# UNITED STATES PATENT AND TRADEMARK OFFICE

10/595,366

## Office Action Summary

## **DETAILED ACTION**

# ATTACHMENT A

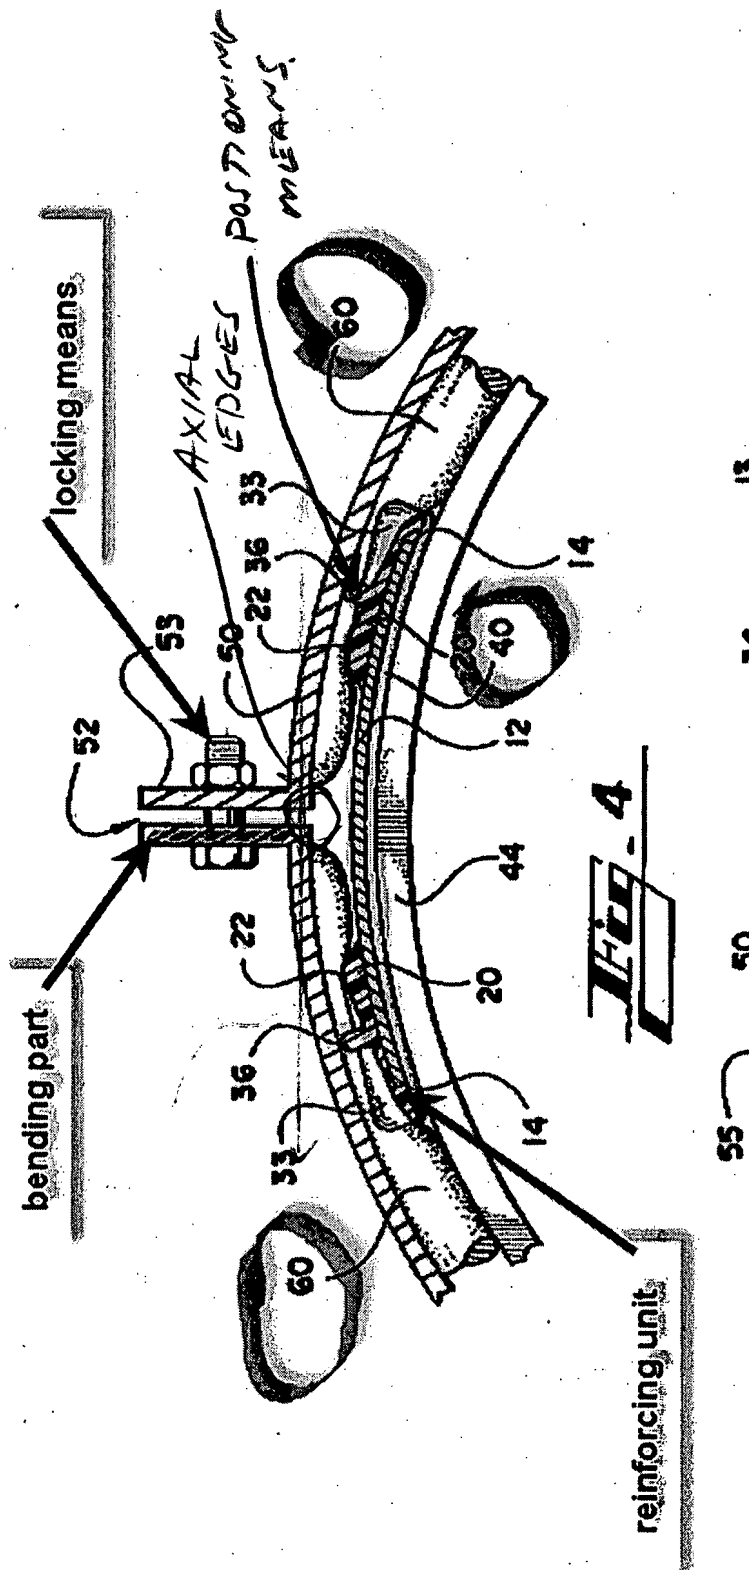
In regard to claims 1, 3/1, 4/1, 4/3/1, 6/1, 6/3/1, and 7/1, as best understood Bridges discloses in Figures 1, 4, and 6, see Attachments A, B, and C, a pipe joint, comprising:

a body part (see Attachment A) provided by rolling a planar material to form a cylindrical structure, the body part having a pair of opposing circumferential edges and a pair of opposing axial edges (see Attachments B and C), the axial edges of the body part defining a longitudinal slot, the body part defining a longitudinal axis (see Attachment C) extending between the pair of opposing circumferential edges, the body part further defining a transverse axis (an arbitrarily chosen exemplary transverse axis noted in Figure 6, see Attachment C) extending between the pair of opposing axial edges of the body part;

a reinforcing unit (see Attachment B) comprising a separate curved plate, the reinforcing unit being reduced in thickness at both ends thereof (see Attachment B) to be in close contact with an inner surface of the body part, the reinforcing unit having a pair of opposing circumferential edges and a pair of opposing axial edges (see Attachment A to observe the respective edges), the reinforcing unit defining a longitudinal axis extending between the pair of opposing circumferential edges (an arbitrarily chosen exemplary longitudinal axis noted in Figure 1, see Attachment A), the reinforcing unit further defining a transverse axis extending between the pair of opposing axial edges of the body part (an arbitrarily chosen exemplary transverse axis noted in Figure 1, see Attachment A);

the reinforcing unit further comprising positioning means (as noted in Figures 1 and 4, see Attachments A and B) extending longitudinally along at least a portion of an outer surface of the reinforcing unit and having a stepped shape (best observed in Figure 4, see Attachment B), the positioning means facilitating the horizontal positioning of the reinforcing unit with respect to the body part when the stepped shape of the positioning means aligns with at least a portion of the longitudinal slot of the body part;

# ATTACHMENT C

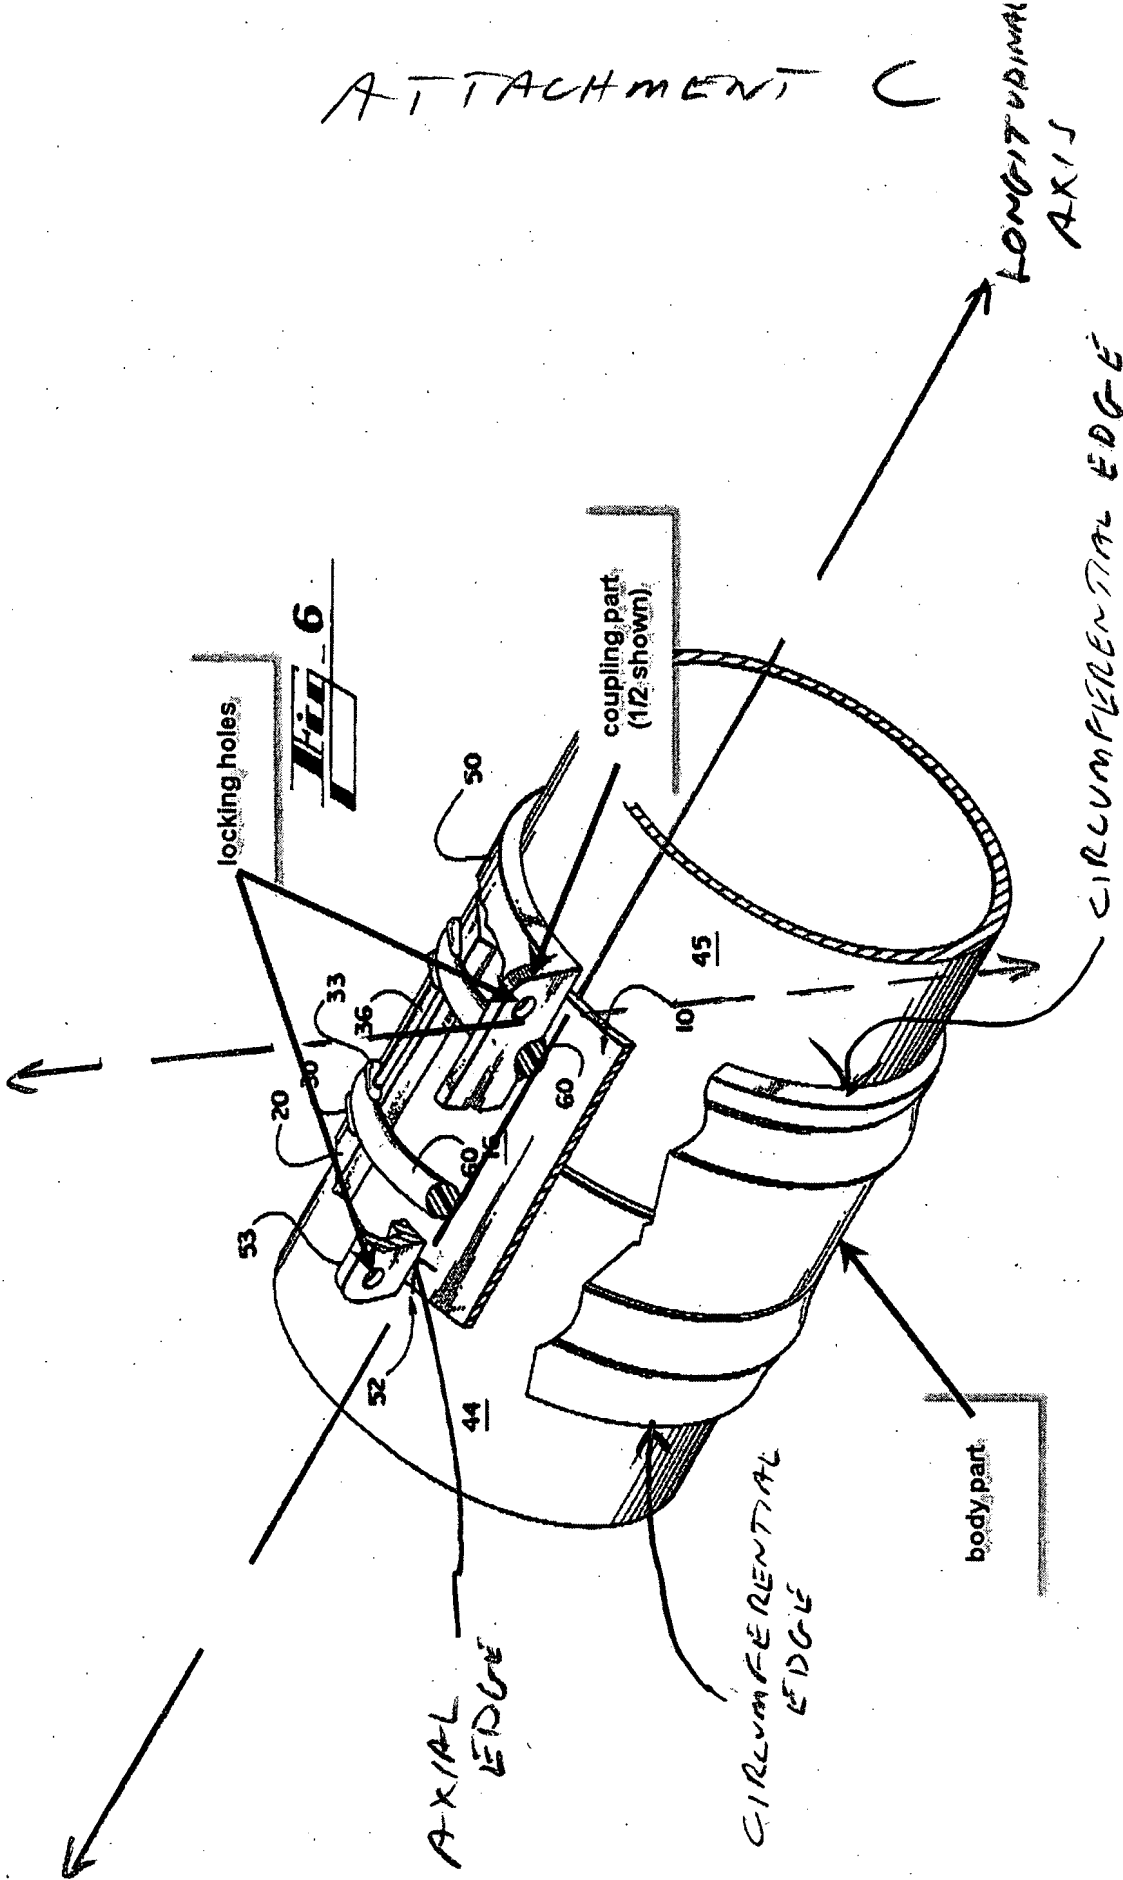
a coupling part (see Attachment C) having a bent surface (the coupling part comprising the noted "bent part" in Figure 4, see Attachment B) at each of both ends of the body part, with a plurality of locking holes (see Attachment C) provided on the bent surface of the coupling part;

# ATTACHMENT D

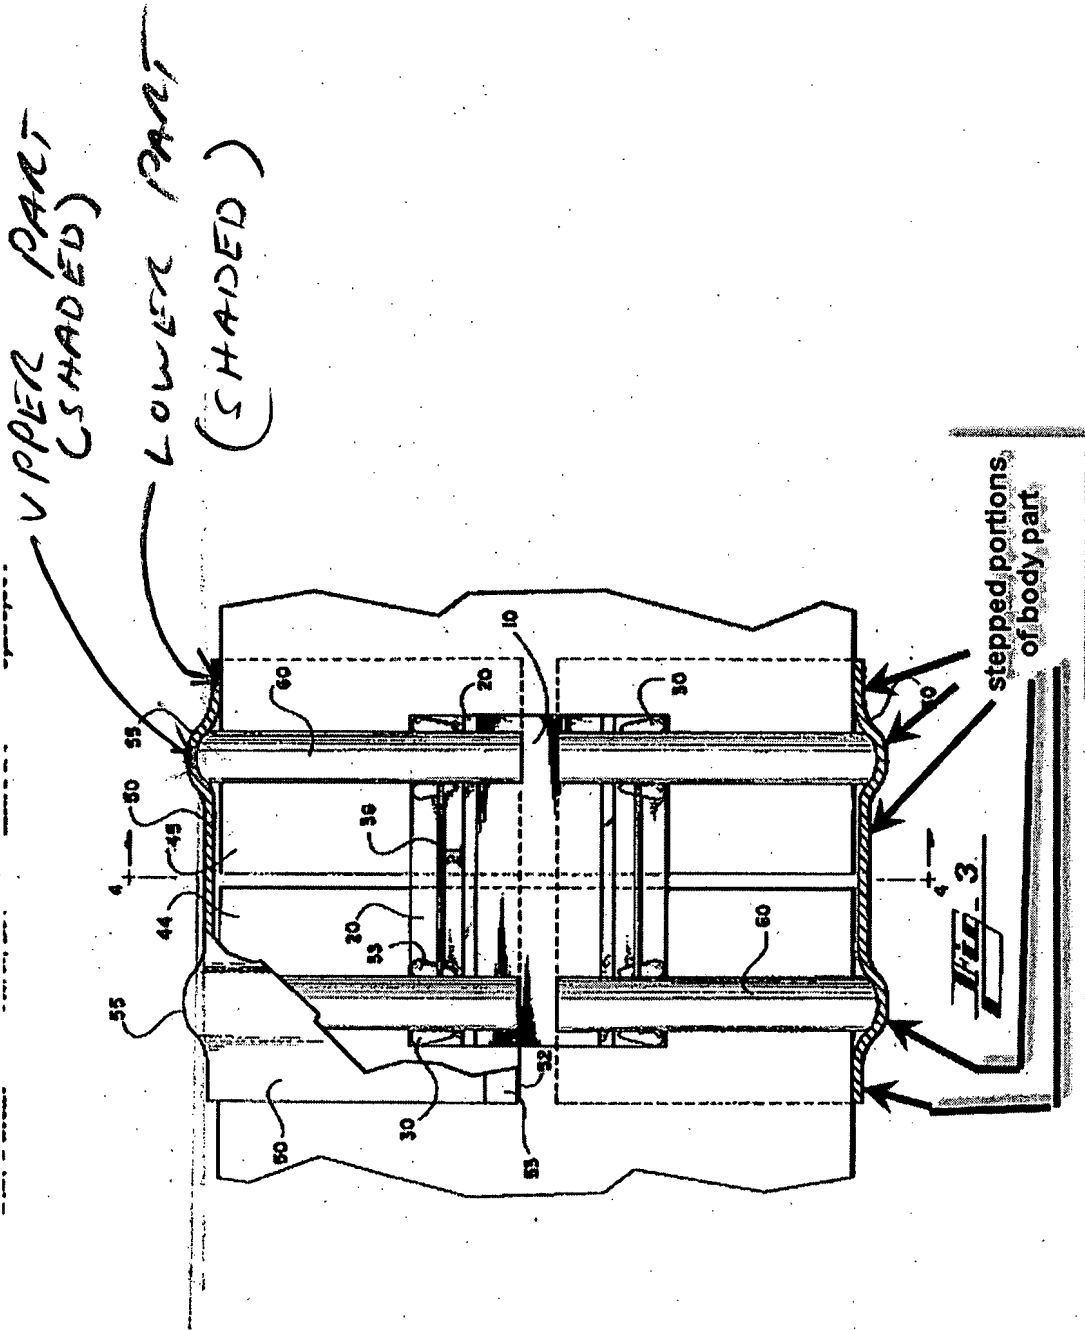
the body part is stepped (see Attachment D) around a predetermined portion thereof so that upper and lower parts of the body part differ in inner and outer diameters from each other (as observed in Figure 3, see Attachment D), each of the upper and lower parts having a consistent diameter (the noted shaded areas have consistent diameters) and defining substantially concentric, graduated parts such that the consistent diameter of one part is greater than the consistent diameter of the other part (as observed in Figure 3, see Attachment D);
